Clinch River Nuclear Site
NRC Docket No. 52-047

Subject: Submittal of Supplemental Information Related to Emergency Planning
Correspondence Between Tennessee Emergency Management Agency and
Tennessee Valley Authority in Support of Early Site Permit Application for
Clinch River Nuclear Site

TVA-TEMA Correspondence Letters

Description of the Clinch River 2-Mile EPZ

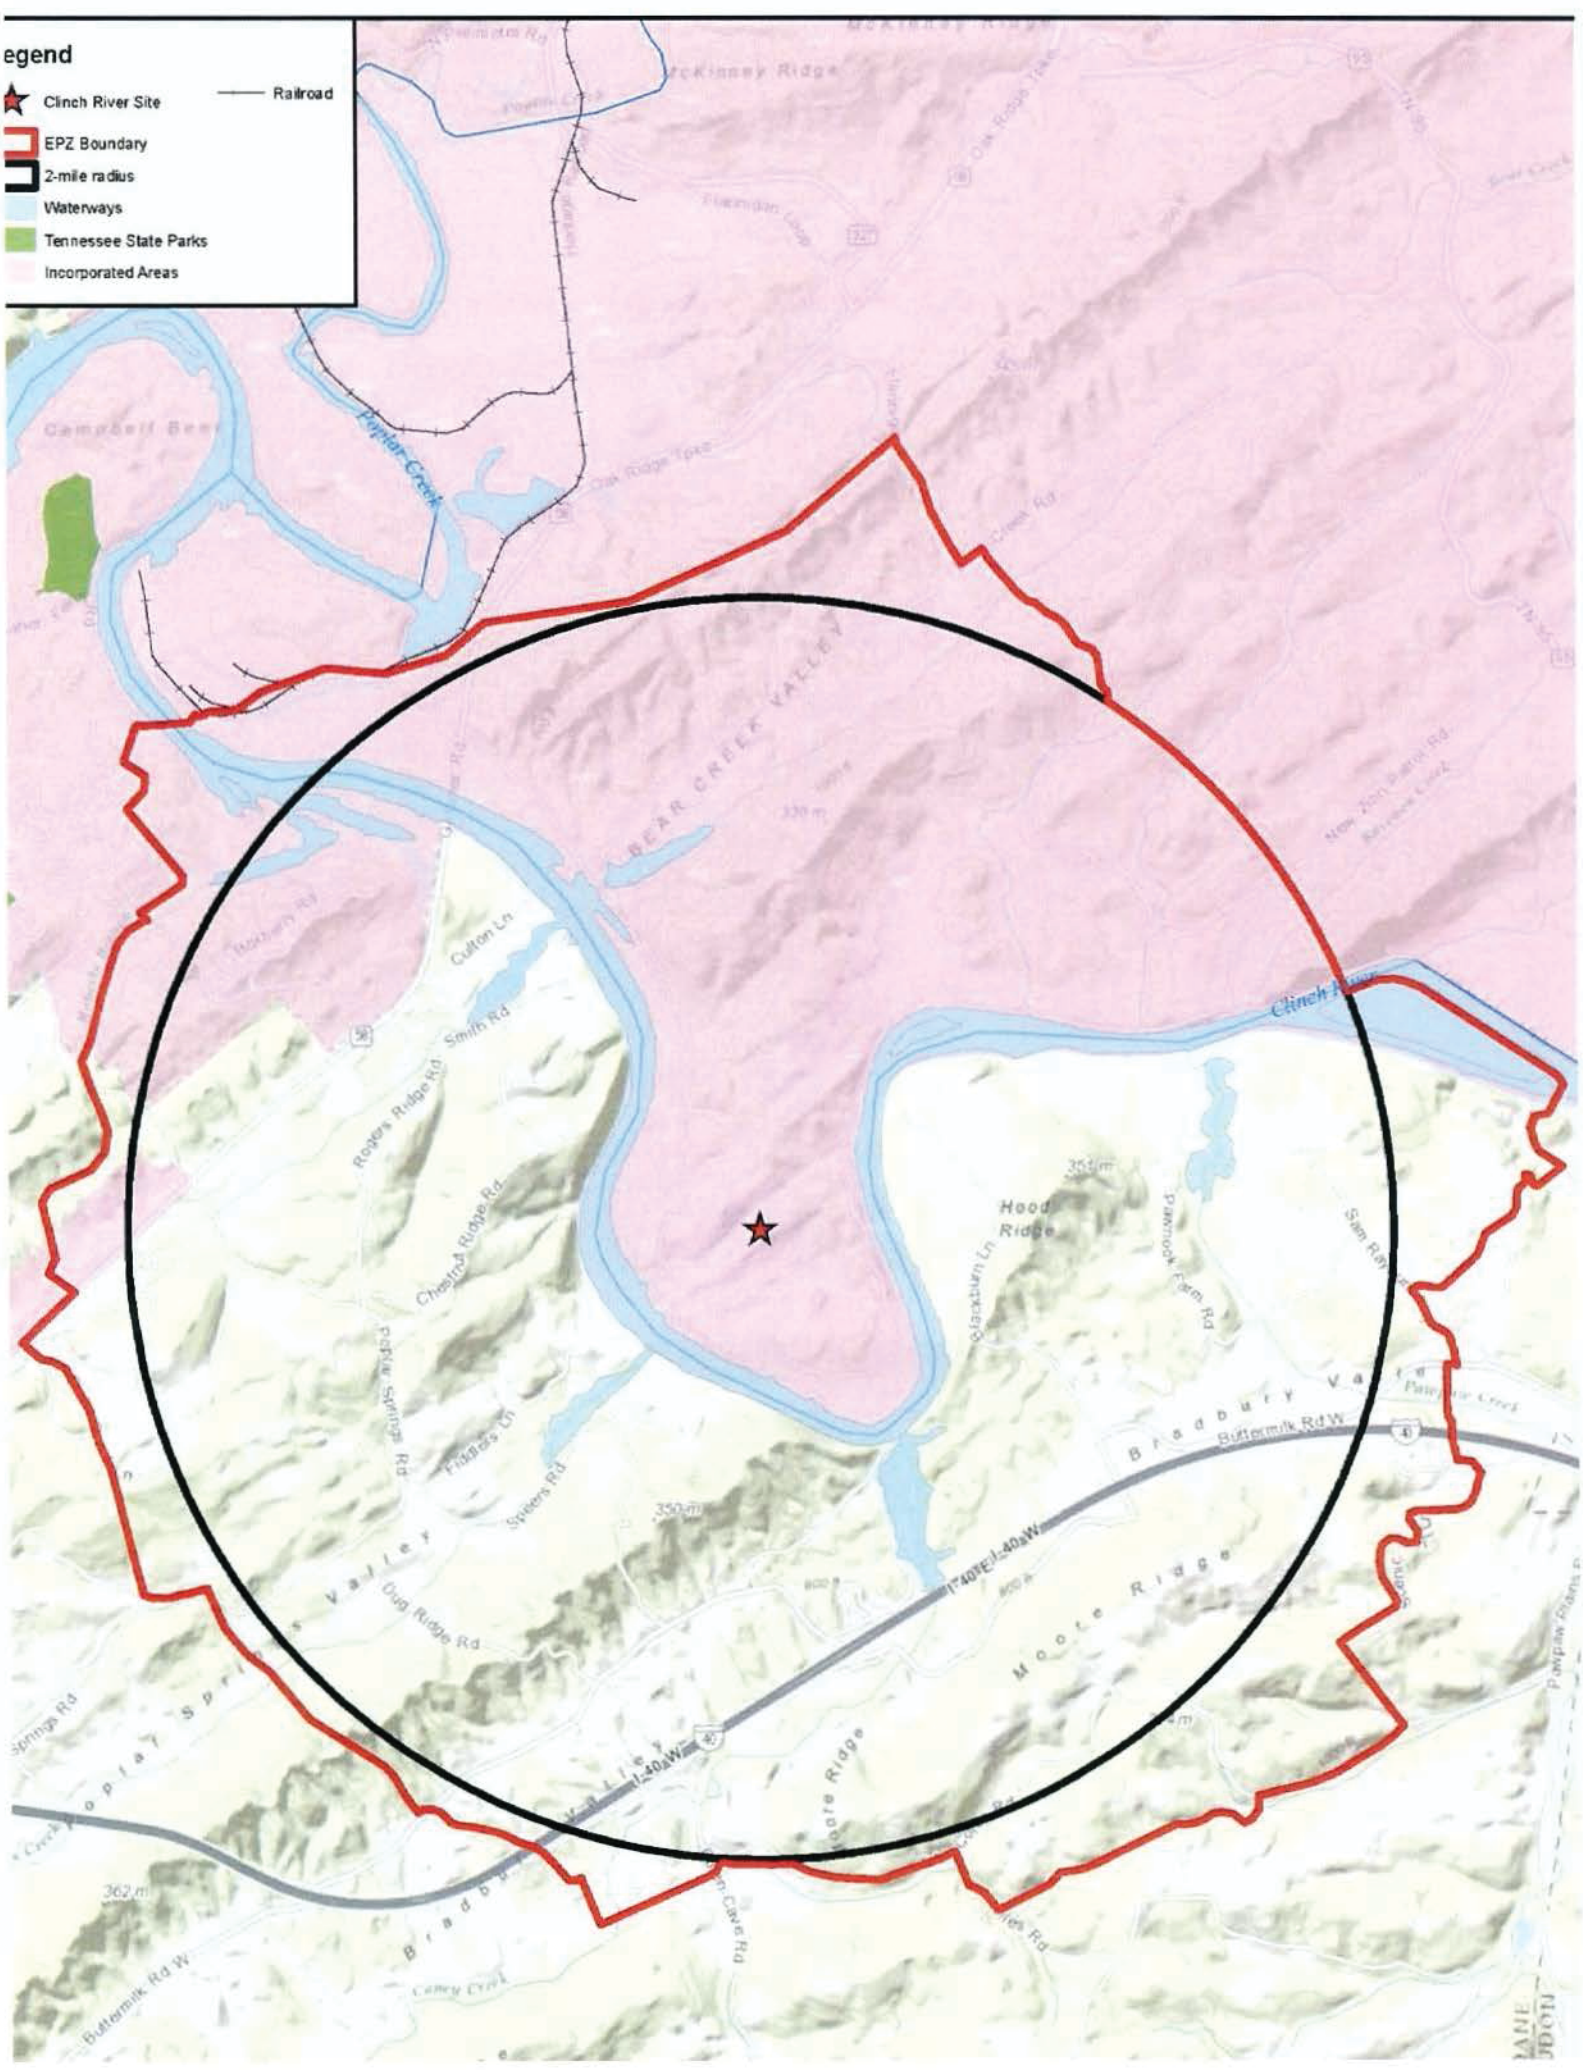
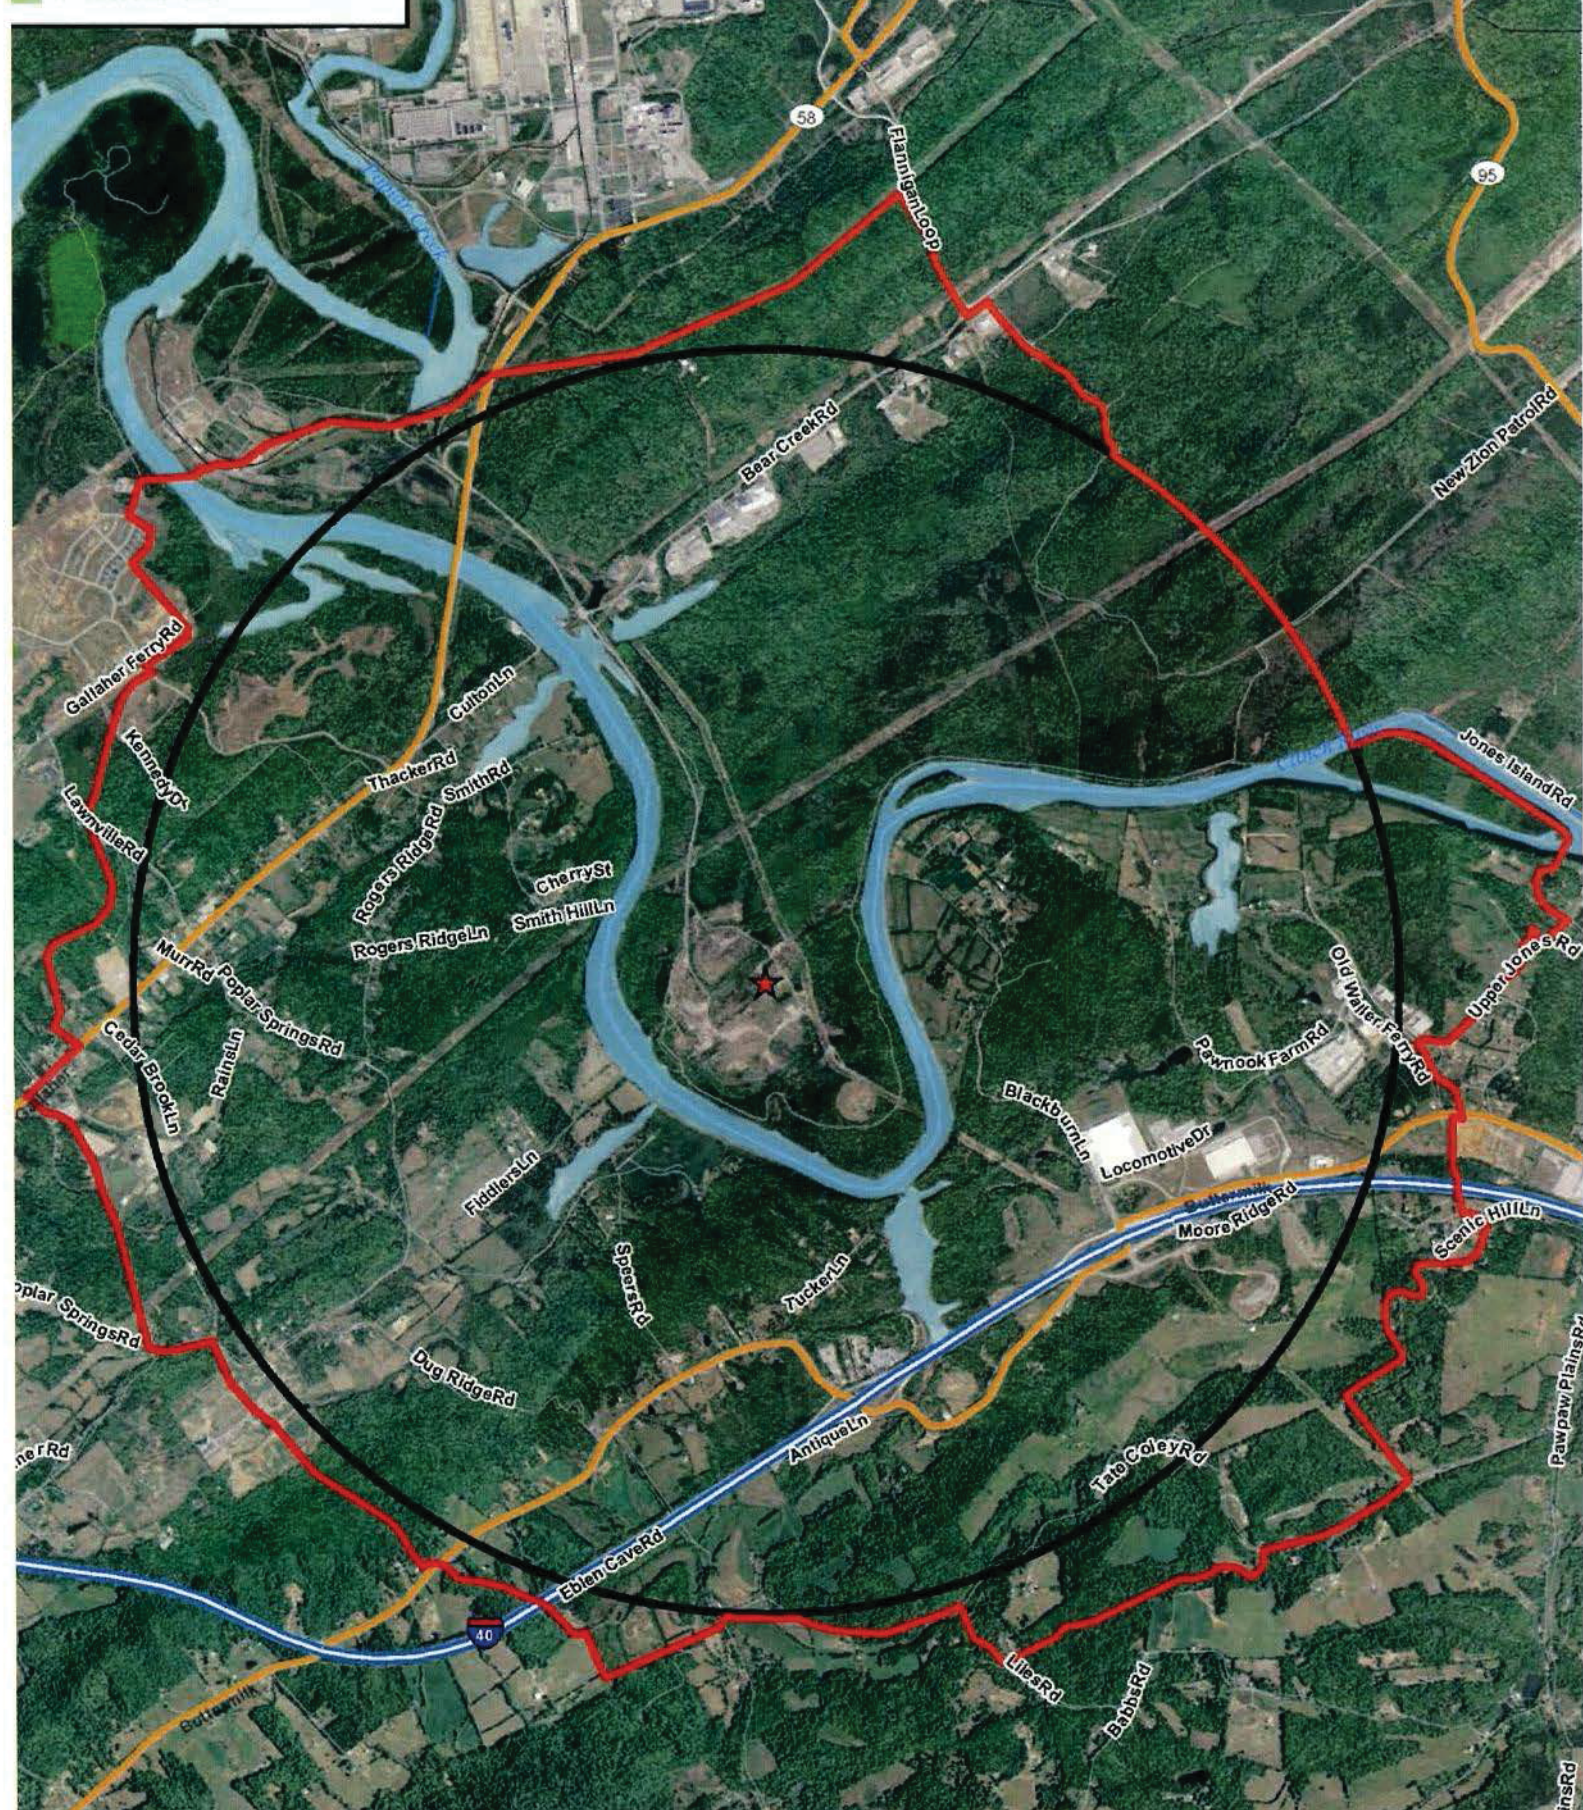
Specifically, information regarding the source term of the fuel for the SMRs needs to be identified. Additionally, specific information on the SMR's design and passive safety systems must be made available for review before any EPZ recommendation can be supported. We also concur with Roane County that an Emergency Alert System which is compatible with the system used by the Department of Energy is needed. Until these and other technical questions have been addressed, sufficient information is simply not available to make a determination regarding the appropriate EPZ for this proposed project.

TEMA will remain a strong supporter of this project and will gladly voice this support to the NRC. However, until more complete technical information is available and the Draft Evacuation Time Estimate study is reviewed, we are not in a position to comment one way or another regarding the appropriate EPZ for the project.
